SUBJECT: Savannah River Site's Responses to the Regulatory Comments on the Effectiveness Monitoring Report (EMR) for the C-Area Groundwater (CAGW) Operable Unit Removal Action (U) July 2021 through June 2022 (SRNS-RP-2022-00530, Revision 0, September 2022) SEMS Number: 82

SRS Responses to South Carolina Department of Health and Environmental Control Comments on: Effectiveness Monitoring Report (EMR) for the C-Area Groundwater (CAGW) Operable Unit Removal Action (U) - July 2021 through June 2022, SEMS Number: 82 (SRNS-RP-2022-00530, Revision 0, September 2022)

**SRS Responses to EPA Comments on the Technical Review of the
Effectiveness Monitoring Report (EMR) for the C-Area Groundwater (CAGW) Operable Unit
Removal Action (U) July 2021 through June 2022, SEMS Number: 82; SRNS-RP-2022-00530,
Revision 0, September 2022**

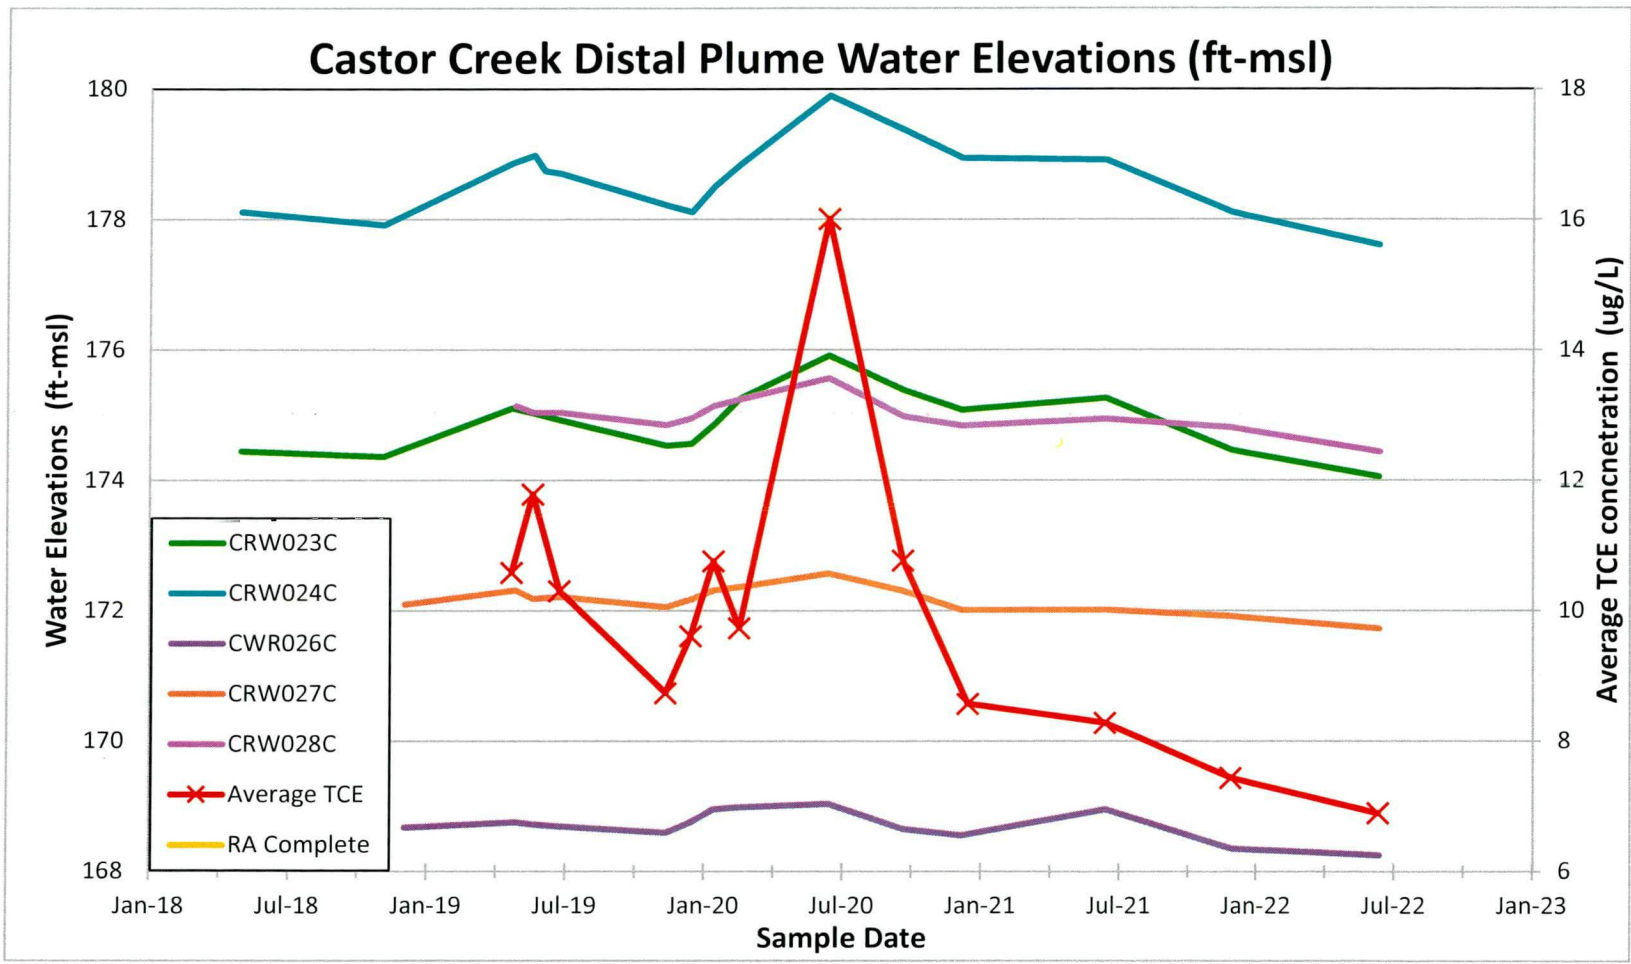
5. Appendix A, CAGW OU NTC RA Analytical Data 2021-2022, Pages A-3 to A-5 of A-6: The table does not identify all concentrations that exceed the MCLs. For example, the TCE result for monitoring well CRW023C collected June 13, 2022 (6.16 µg/L) is not highlighted red to indicate an exceedance of the MCL (5 µg/L). Instead, this result is indicated to be an estimated value; however, an estimated result is useable and should be identified as an exceedance. Please revise this table to identify all exceedances of the MCLs.

For the table in Appendix A, the results for TCE at CRW023C collected on June 13, 2022 is color coded properly for a J qualified result. The reporting software used to create this table is limited and currently does not have the ability to color code results that are both J qualified and that exceed an MCL. SRS will look into uniquely identifying results that are both J qualified and exceed an MCL for future reports. No change to the current report is proposed.

Attachment 1: Water Table in CAGW OU RA Area

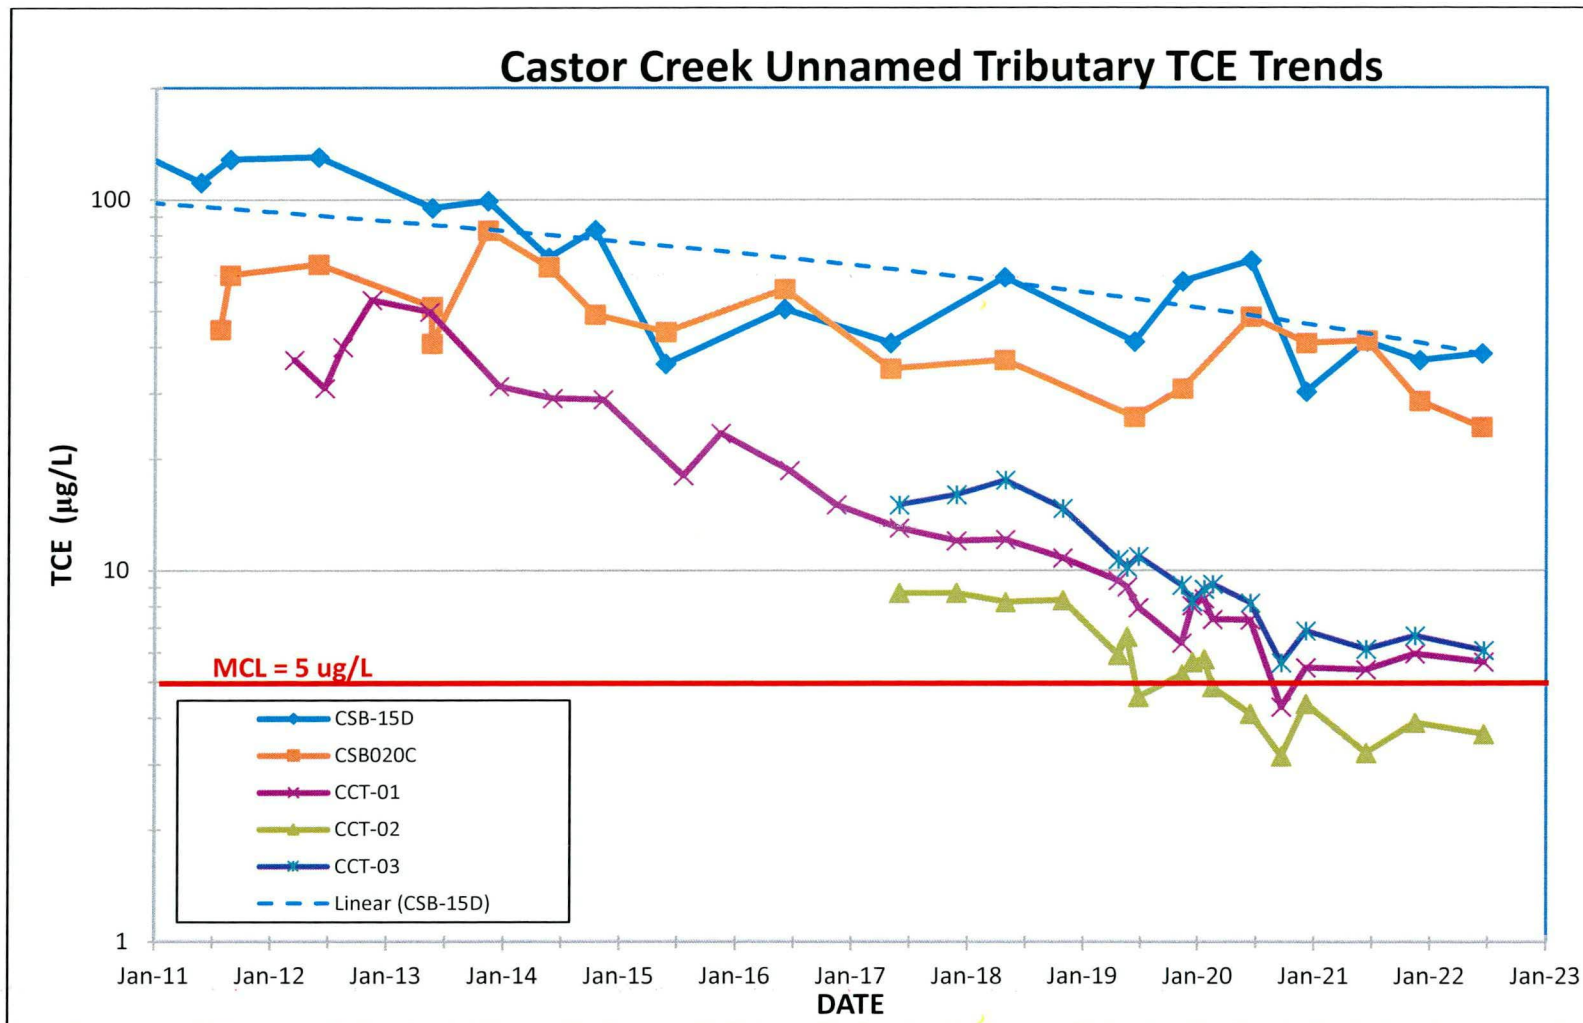
2. The EMR notes that groundwater concentrations of TCE at downgradient wells CRW027C and CRW028C are increasing; however, the EMR does not discuss why TCE may be increasing at these wells or if additional wells in this area may be necessary. For example, it is unclear if injections in the first transect may have pushed the plume downgradient. Also, since downgradient wells CRW027C and CRW028C are located on the southeastern edge of the plume, it is unclear if additional monitoring wells would be useful for determining if the TCE plume is migrating. Please revise the EMR to discuss potential reasons for increasing concentrations of TCE at downgradient wells CRW027C and CRW028C and if any additional actions may be necessary.

There could be several reasons for the increased TCE groundwater concentrations at wells CRW027C and CRW028C. In June 2020, the water table rose for all the wells in the CAGW

OU RA monitoring network (Attachment 1: Water Table in CAGW OU RA Area), and there was a corresponding increase in the average TCE groundwater concentration. It is likely the elevated water table entrained TCE that had been stranded in the vadose zone at a previously high-water elevation, and/or from vapor intrusion into the vadose zone. Wells CRW027C and CRW028C are downgradient of the injection areas and very near the unnamed tributary; therefore, it is possible the groundwater with elevated TCE from 2020 is now impacting these wells.

Alternatively, the oil injections in 2019 could have pushed the TCE plume toward these wells in 2020. A combination of the oil injections moving the TCE plume toward these wells and increased TCE groundwater concentrations from a rising water table may be responsible for increased TCE concentrations at CRW027C and CRW028C.

Attachment 3: Updated Figure 15 from EMR

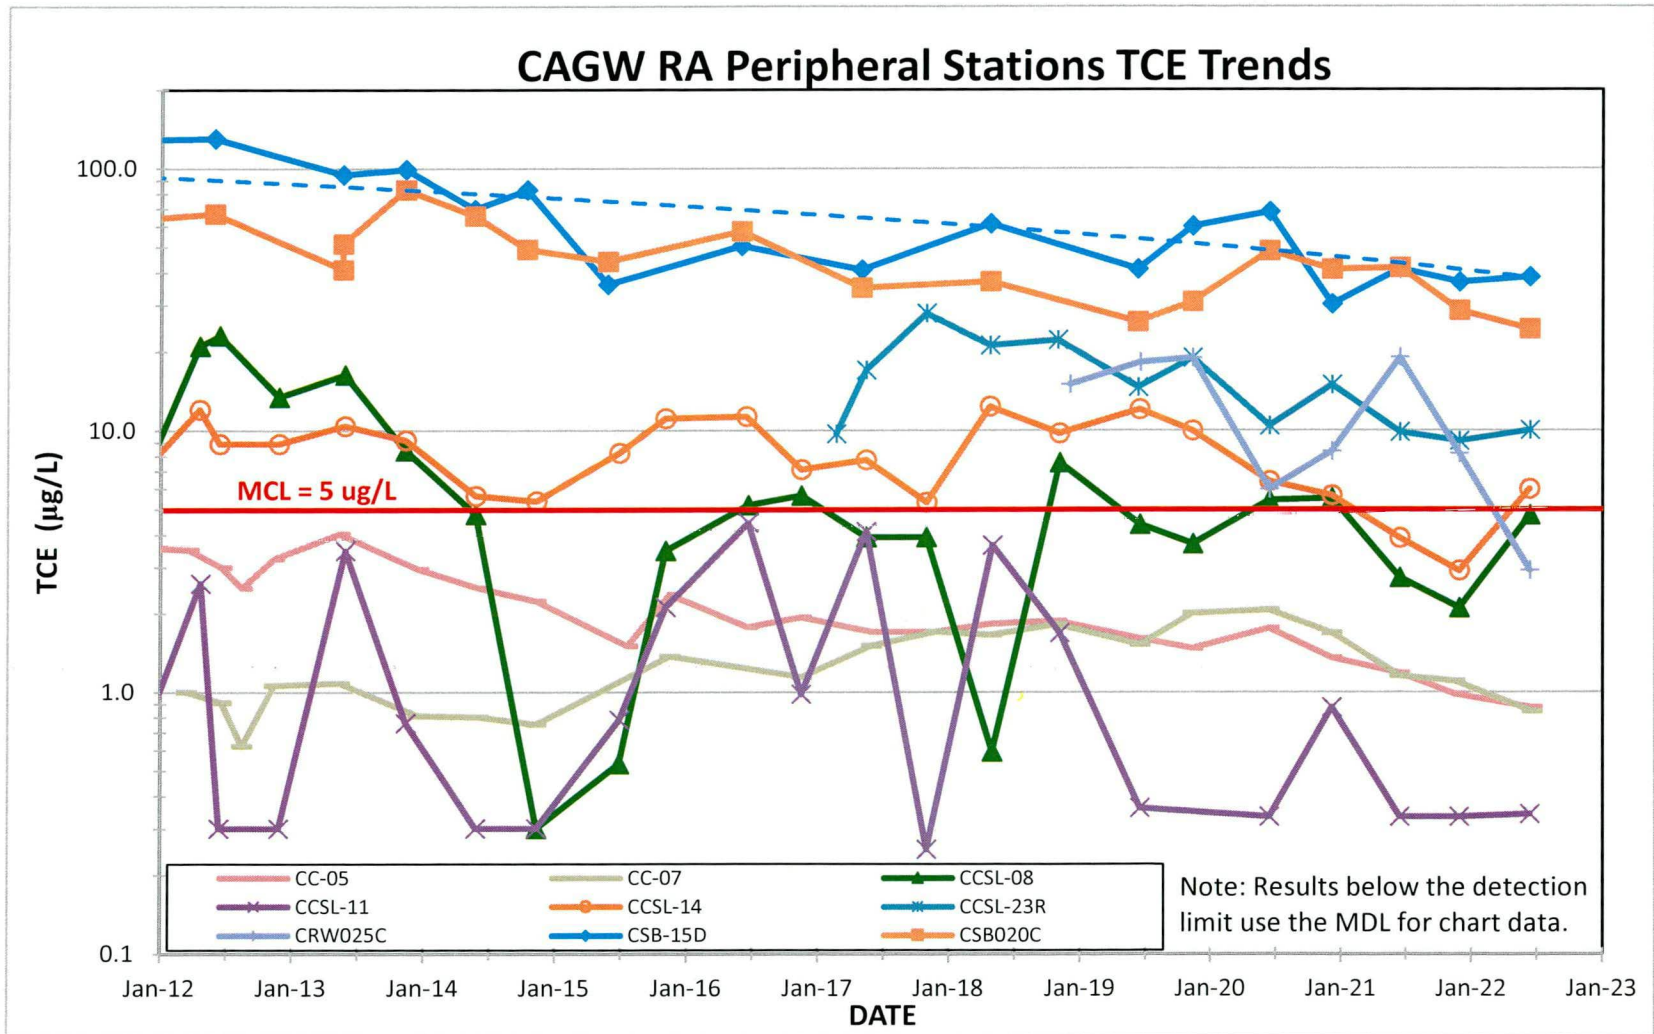
4. The concentrations of methane over time in monitoring well CRW023C are not consistently presented in the ERM. The text of Section 4.4.1.6 (Methane; Page 17 of 110) indicates there was an increase in methane concentrations at CRW023C; however, Appendix A (CAGW OU NTC RA Data) reports the concentrations of methane in CRW023C as not-detected below the sample quantitation limit (SQL) of 25 micrograms/liter ($\mu\text{g/L}$) in 4Q21 and detected at 23 $\mu\text{g/L}$ in 2Q22, which is below the SQL. Further, Figure 15 (CRW023C Post-RA Groundwater Trends) indicates concentrations of methane were 10 $\mu\text{g/L}$ since June of 2020, and two data points are included for the June 2022 sample, even though only one result is reported for this sampling event in Appendix A. Please revise the EMR to consistently present the concentrations of methane measured in monitoring well CRW023C.

Figure 15 displays methane concentrations over time for CRW023C since baseline conditions. During 2020, a different analytical laboratory was contracted and the method detection limit (MDL) was increased from 0.046 $\mu\text{g/L}$ to 10 $\mu\text{g/L}$ for methane. The MDL is used for trend analysis when the concentration of the constituent is non-detect.

The two data points presented in Figure 15 for June 2022 are a regular sample and a field duplicate sample for CRW023C. The inclusion of the field duplicate result was in error. Figure 15 will be revised appropriately in the next annual report. Attachment 3 provides an updated Figure 15. No changes to the current report are proposed.
